UNITED STATES OF AMERICA
NUCLEAR REGULATORY COMMISSION

In the Matter of)	
TEXAS UTILITIES ELECTRIC)	Docket Nos. 50-445 and
COMPANY, ET AL.)	50-446
(Comanche Peak Steam Electric)	(Application for
Station, Units 1 and 2))	Operating Licenses)

AFFIDAVIT OF JOHN C. FINNERAN, JR. IN SUPPORT
OF APPLICANTS' REPLY TO CASE'S ANSWER TO
APPLICANTS' MOTION FOR SUMMARY DISPOSITION
REGARDING CONSIDERATION OF FRICTION FORCES

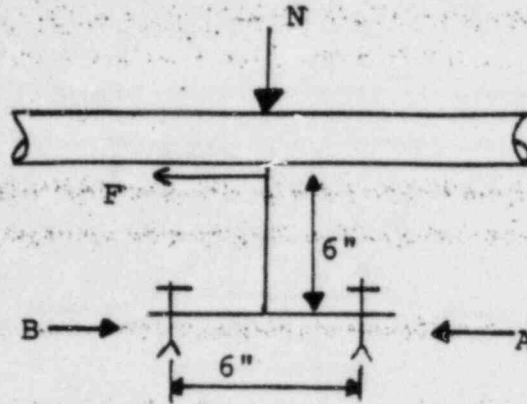
CASE next asserts that when the effects of friction alone are considered, the stress ratios (load divided by allowable) are of such magnitude that inclusion of mechanical loads would create an overstressed condition (Affidavit at 7). CASE illustrates its position using a calculation Applicants prepared in response to an NRC Staff question which showed that when the effects of friction alone are calculated for a particular support the stress ratio was determined to be .775. CASE contends that this leaves only .225 of the ratio for mechanical loads. CASE does not acknowledge, however, that (as I indicated in my statement to Mr. Fair referenced by CASE) friction forces do not act alone, and that when the normal load (which gives rise to the friction force) is included in the calculation, it tends to offset the effect of the friction force. In this instance, when friction and the normal load are combined the stress ratio actually drops from the .775 calculated for friction alone to .46. Specifically, as noted in Table 1 of my original affidavit, the loading combination of friction plus Level A loads for this support (SI-1-029-055-S32R) produces a .96 stress ratio (3042 divided by 3181), using a conservative calculation technique (treating the compression force in the support member as a tension load on the weld (see p. 4 of 7, bottom of calculation)). To compare accurately the friction plus normal load combination with the friction load alone it is

necessary to evaluate the weld stresses as they actually occur. Doing this for the level A loads plus friction load combination for the weld yields:

$$f_t \text{ (weld tension stress)} = \frac{4972 (15.5)}{34.47} - \frac{16573}{20.8} = 1439 \text{ lb/in}$$

Then the resultant tension stress on the weld is:

$$f_R = (1439^2 + 239^2)^{1/2} = 1459 \text{ lb/in}$$

The resulting stress ratio is then .46 (allowable stress = 3181 lb/in). Performing a similar evaluation for Level B loads yields a stress ratio of .42. In sum, it is simply incorrect to assert, as CASE does, that the stress ratios calculated considering friction alone are at all indicative of the stress ratios for combined mechanical and friction loading.
